Submission to the Northern Beaches Local Planning Panel

Re: DA2021/1032, 8 Delecta Ave, Clareville - Alterations and additions

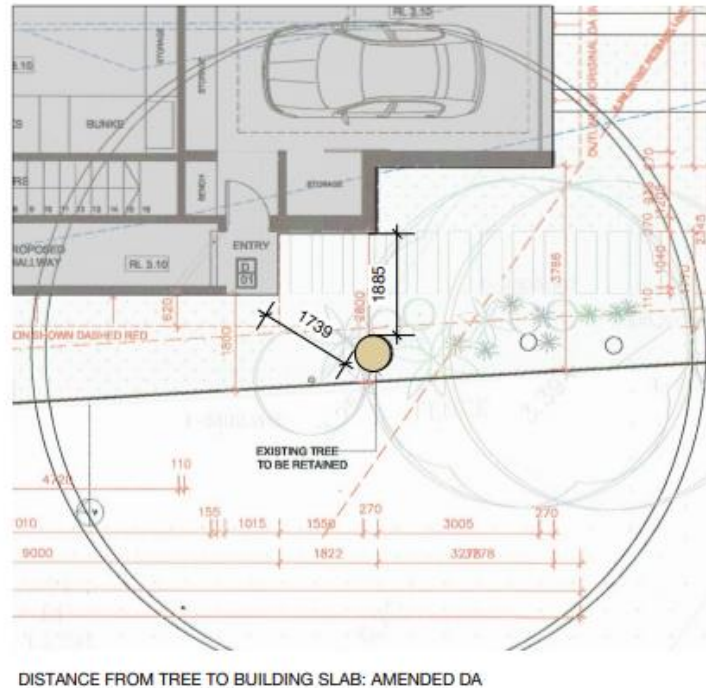
b. **Native Melaleuca (tree #5) still in danger** – this tree is the only substantial mature native canopy tree on site. While the amended development proposal now has provided “greater opportunity for the retention of the tree”, given the proximity of the building to the tree, its survival is in jeopardy. The original arborist’s report accompanying the DA stated that the tree was of high retention value and high significance – indeed, it was a condition of the DA approval at #6, 4 years ago, that it be protected. The distances of the built form from the tree’s trunk are depicted in the diagram below:

The distances from tree trunk to the built form are 1.739m on the oblique and vertically 1.885m. These distances are far too close to ensure the tree's survival – in fact, the key determinant is the potential impact of the building on the tree's root zone. The tree protection zone (TPZ) is 6.9m, and the structural root zone (SRZ) is 2.8m. Building encroachment to 4.75m from the tree or within <10% of the TPZ area (but outside the SRZ) is permissible. However, the amended development proposal has the building's footprint more than 10% inside the TPZ and also well within the SRZ. Therefore, an arborist's report (involving exploratory excavation and root mapping) is required that demonstrates that the tree will remain viable. This report needs to be commissioned (at the proponent's expense) before the development amendments to the plans. It is nonsensical to issue the construction certificate, as su

APPENDIX – Before and after comparison of bulk and scale

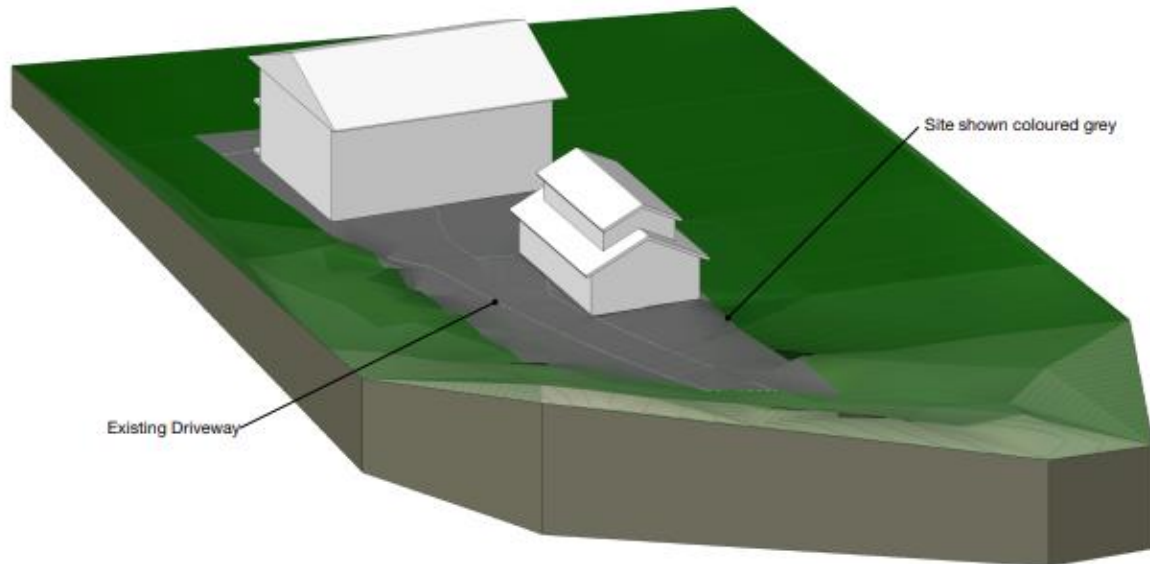
By their nature, qualitative issues are subjective in judgement, and it appears that Council has dismissed all of our qualitative concerns, labelling the impacts as "reasonable". We strongly disagree. This is a development out of character and scale with other homes in this special environment. It is inconsistent with the objectives of the LEP (refer to clause 1.2) and the aims of the E4 zone "to provide for low impact residential development in areas with special ecological, scientific or aesthetic values", such as Clareville (Long) Beach, and "to ensure that residential development does not have an adverse effect on those values". The proposed development does not adhere to these goals - refer to the Appendix for a before and after comparison of bulk and scale.
